You need to add the following Parts to the manual ECUs*
to make the additional PWM Output (Low Side Driver) on Pin B24 work:

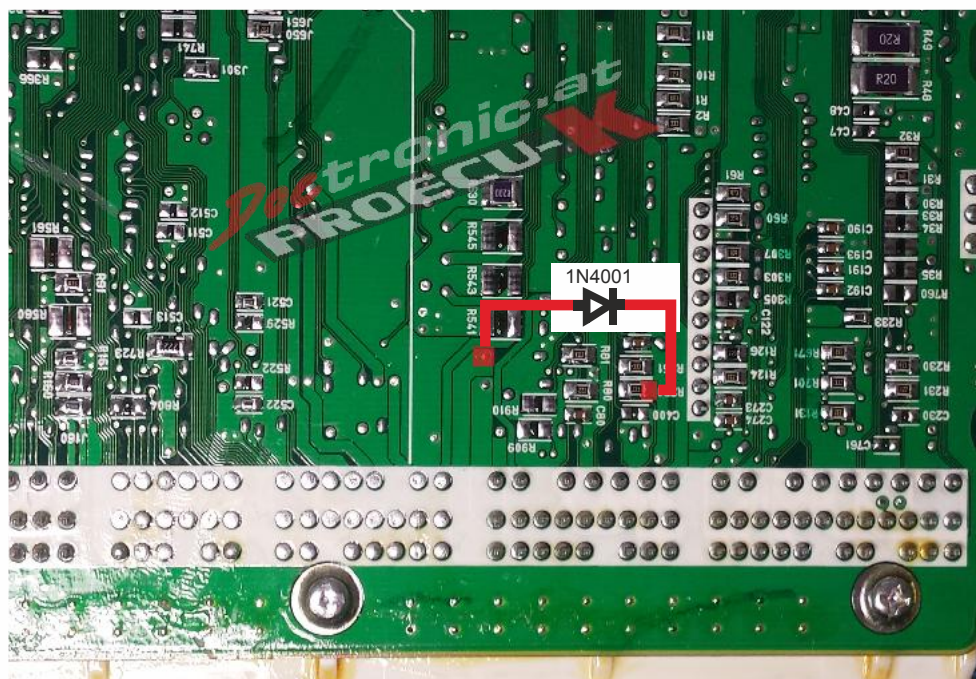
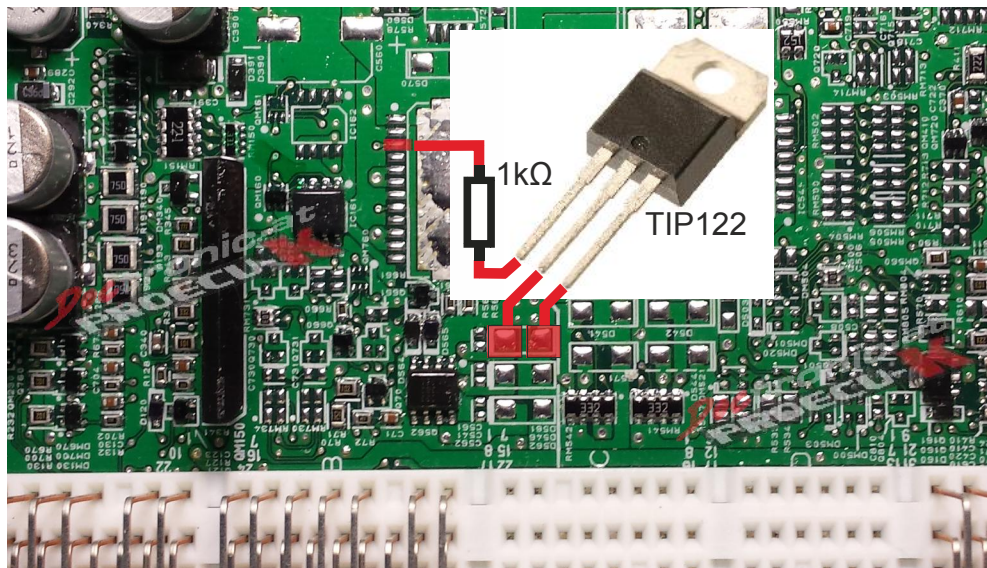
- TIP122 (NPN Power Transistor)
- 1kOhm Resistor
- 1N4001 Diode

* (on automatic ECUs there is already a High Side Driver installed)
